TRANSMITTAL OF ADDITIONAL INFORMATION TO ADDRESS KEY TECHNICAL
ISSUE (KTI) AGREEMENT UNSATURATED AND SATURATED ZONE FLOW UNDER
ISOTHERMAL CONDITIONS (USFIC) 5.02

**RESPONSE TO U.S. NUCLEAR REGULATORY COMMISSION ADDITIONAL
INFORMATION NEEDS ON GROUNDWATER SPECIFIC DISCHARGE**

**RESPONSE TO U.S. NUCLEAR REGULATORY COMMISSION ADDITIONAL
INFORMATION NEEDS ON FLOW FIELD FOR FUTURE CLIMATE STATES**

Figure 1. Cumulative Distribution Function of Uncertainty in Groundwater Specific Discharge Multiplier

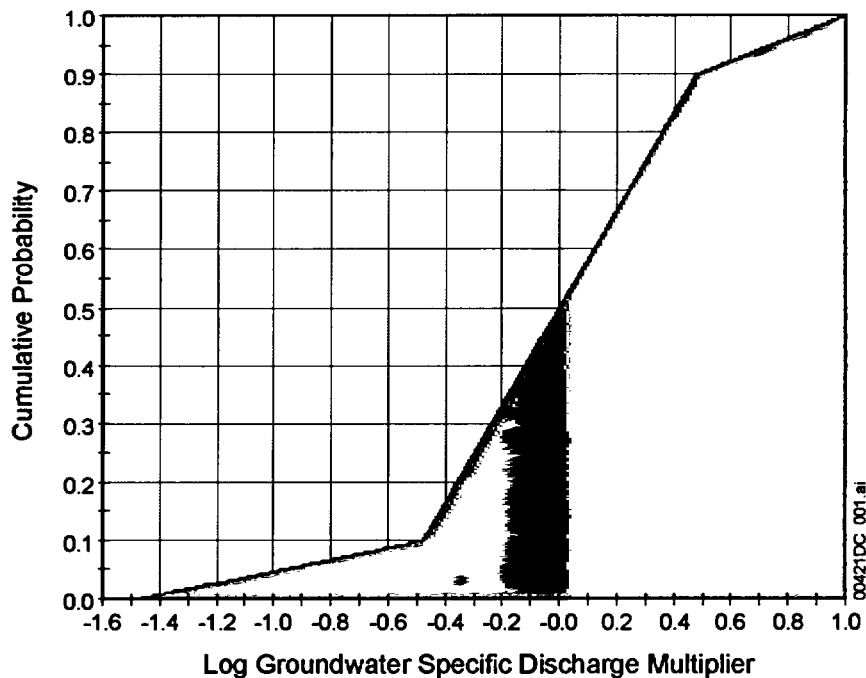
If the U.S. Department of Energy (DOE) decides to incorporate the Saturated Zone (SZ) Flow and Transport Expert Elicitation in the license application but departs from the original panel's recommendations, DOE will need to provide the technical bases for this change in order to complete Agreement Unsaturated and Saturated Flow under Isothermal Conditions (USFIC) 5.02 (Schlueter 2003).

This reduction in uncertainty in specific discharge is reflected by a narrowing of the cumulative probability distribution in the saturated zone flow and transport model abstraction (BSC 2003) over the middle 80% of the probabilities in the distribution. Specifically, the middle 80% of the distribution is assigned an uncertainty range that amounts to approximately 1/3 to 3 times the best estimate of specific discharge, which is consistent with the range of specific discharge estimates from the single-well tracer tests at the Alluvial Testing Complex. However, to account for potential convergence or divergence of flow pathways in the saturated zone (which would affect specific discharge at any given location) and also uncertainty associated with the representativeness of the Alluvial Testing Complex location, the upper 10% and lower 10% of the cumulative distribution for specific discharge are extended beyond the uncertainty range

indicated by the Alluvial Testing Complex single-well tests. The lower 10% of the distribution is extended from 1/3 to 1/30 of the best estimate of specific discharge, and the upper 10% of the distribution is extended from 3 to 10 times the best estimate (Figure 1). Both of these extensions are assumed to be log-linear. The overall uncertainty range of nearly 2.5 orders of magnitude in Figure 1 approximately corresponds to the uncertainty range originally recommended by the expert elicitation panel for the fractured volcanics. A single distribution for specific discharge is used for both the volcanics and the alluvium because the specific discharge is expected to be of roughly the same magnitude in both parts of the flow system. Also, overall radionuclide transport times will be dominated by transport times in the alluvium because of the greater flow porosity in the alluvium relative to the volcanics.

Uncertainty in the groundwater specific discharge is incorporated into saturated zone flow and transport model abstraction (BSC 2003) using the continuously distributed groundwater specific discharge factor parameter. This parameter is a multiplication factor that is applied to the permeability and specified boundary flux values in saturated zone flow and transport model abstraction (BSC 2003) to effectively scale the simulated specific discharge in the model. Note that a separate steady-state groundwater flow field is simulated for each realization of the system using the value of groundwater specific discharge factor. The groundwater specific discharge factor sampling is performed on the log-transformed values of the specific discharge multiplication factor (BSC 2003). The cumulative distribution function of uncertainty in the groundwater specific discharge multiplier is shown in Figure 1.

Figure 1. Estimated Water-Table Elevations for Future Glacial Climatic Conditions

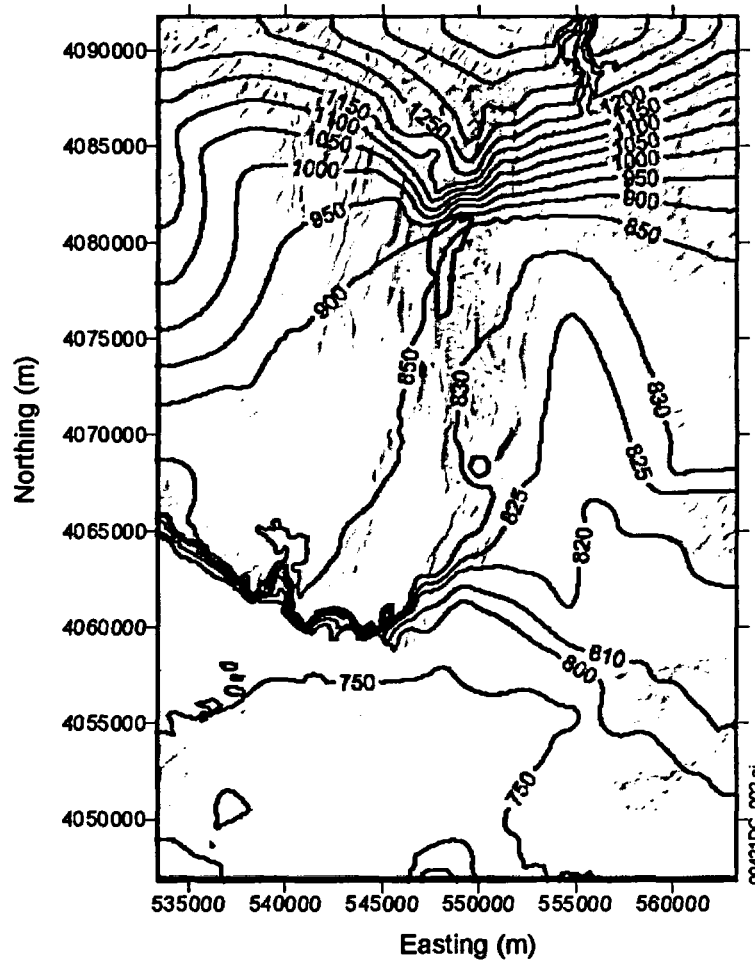
Uncertainty in present-day flow fields is considered only with regard to horizontal hydrologic anisotropy in the U.S. Department of Energy (DOE) site-scale saturated zone flow model. No uncertainty or variability in climate-change time or magnitude are considered. When a climate change does occur, no uncertainty or variability in flow paths or water-table elevation are considered. This is especially important, considering that present-day flow fields represent only 6% of the compliance period. Greater recharge can be expected during the following climate states with an expected rise of the water table. Future conditions of the groundwater flow system at Yucca Mountain are unknown, but estimates from past changes in climate and observation of paleosprings deposits have indicated 80 to 120 m higher water-table elevations. Contaminants traveling near the surface of the saturated zone during future climate states would be in different hydrostratigraphic units at different locations. Transport modeling results could be affected. In addition, present-day flow paths may diverge for the monsoon and glacial-transition climates, and transport times altered. DOE has discussed at various public meetings plans to change the current method for determining flow fields for future climates. These changes need to be documented, or the justification for not making any changes needs to be shown, in order to complete Agreement Unsaturated and Saturated Flow under Isothermal Conditions (USFIC) 5.02.

The estimated elevations of the water table under wetter glacial climatic conditions, as calculated by WTCNVYD V.1.00 (SNL 2002), are shown in Figure 1. The contours for the water-table surface are generally similar to the present water table, with the exception of the area in Fortymile Canyon in the northern part of the model domain and in some areas in the south-central and southwestern parts of the model domain (BSC 2003a, Section 6.4.5).
